HOUSTON PUBLIC WORKS CAPITAL PROJECTS

Avalon Place Neighborhood Sewer System Improvement Project

CIP No. R-002011-0089

Avalon Place Survey/Public Comments

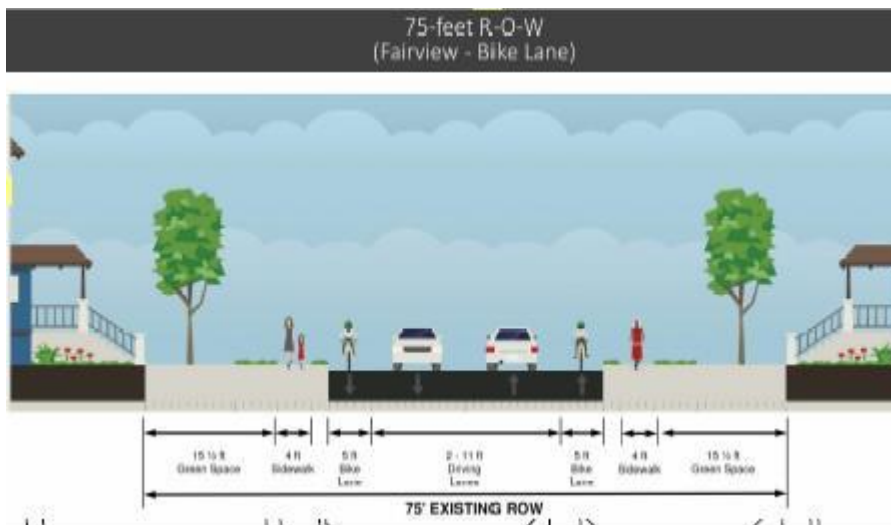
Primary Concern- Improvements to Traffic Signing, Striping, and Pedestrian Safety

- Overall, the main concern expressed was the perception of high vehicular speeds on Fairview St., east of Shepherd Dr.

- 92% of responders supported or did not express concerns for the bike lanes.
9% of responders oppose bike lanes.
- 96% of responders supported or did not express concerns for reducing parking along Fairview St.
4% of responders oppose reducing parking along Fairview St.
 - The comments opposed to parking reductions are mostly-related to parking for the restaurant located at Hazard St. and Fairview St.

- Provide 2-11 feet wide travel lanes and 2-5 feet wide bicycle lanes from Driscoll St. to Persa St. This includes modifying the mobility through the existing intersection of Shepherd Dr. and Fairview St. to include bicycle movements across the intersection.

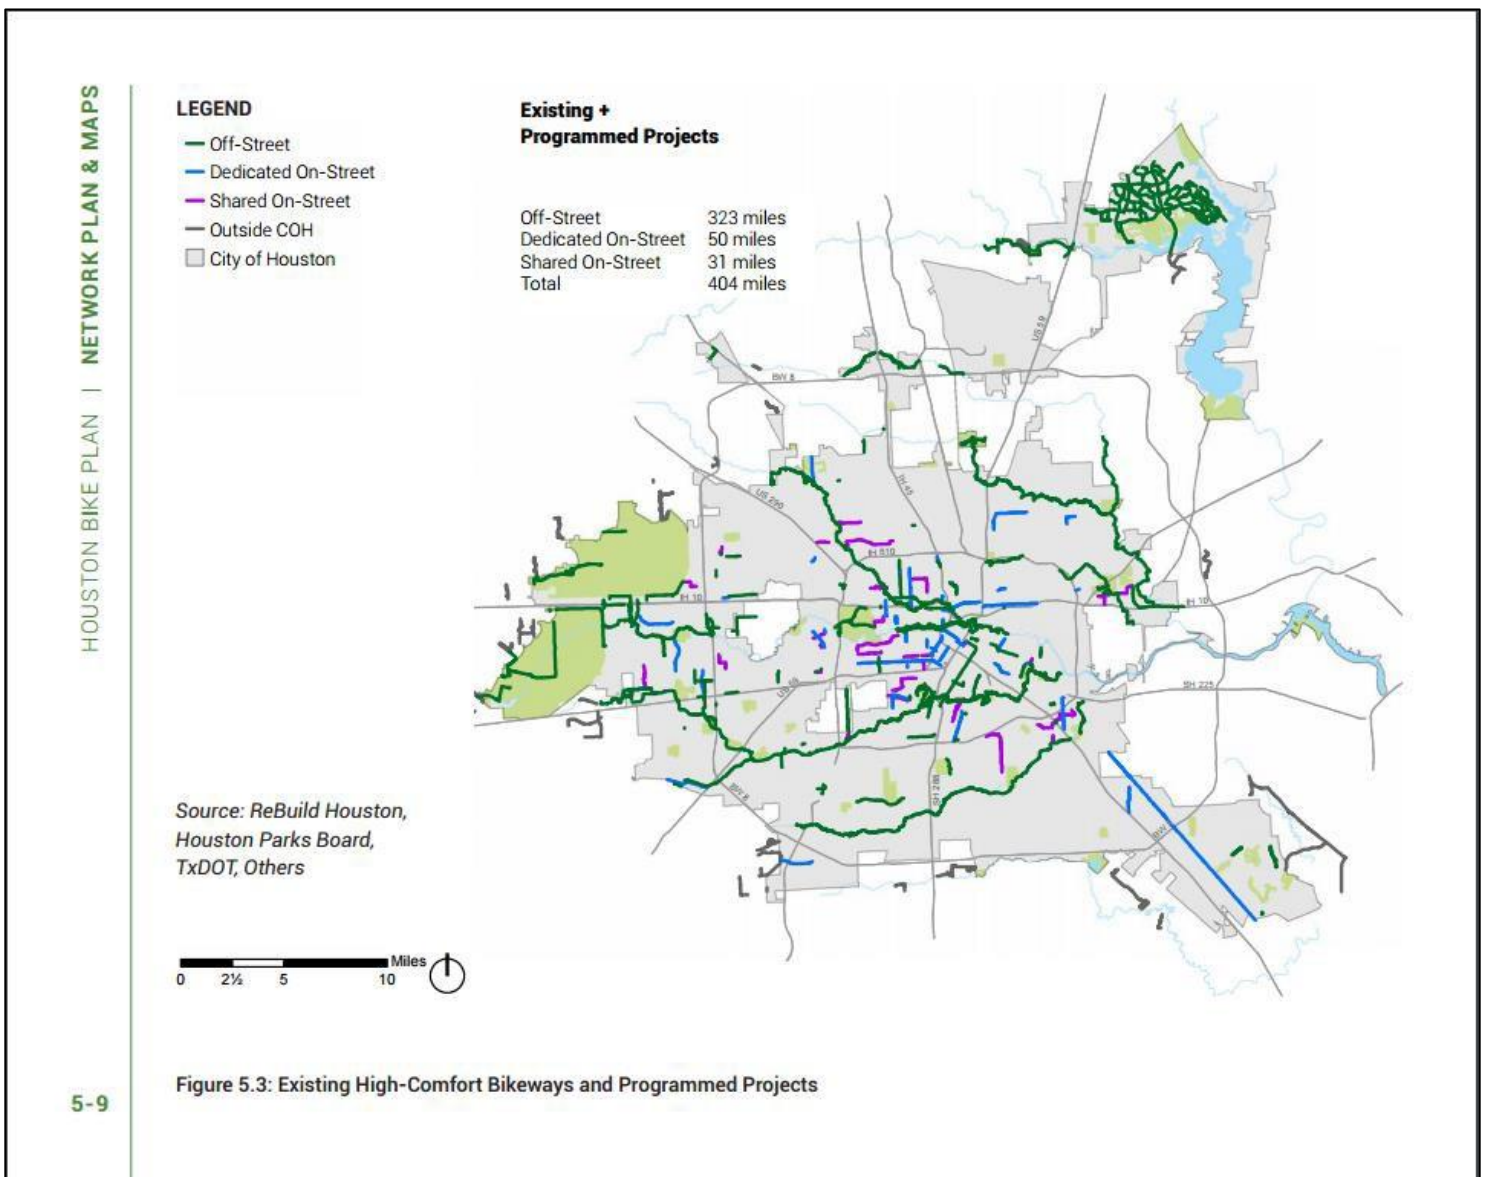
- 71% of responders prefer **Option 1**- City of Houston Design Standard.
- 29% of responders prefer **Option 2**- City grades the subgrade to proper slope and homeowner works with their contractor to finish the driveway with their desired finish.
 - **NOTE: Owner pays for the work performed by their contractor with Option 2.**

- Coordinate with property owners prior to construction for owner's driveway construction preference.
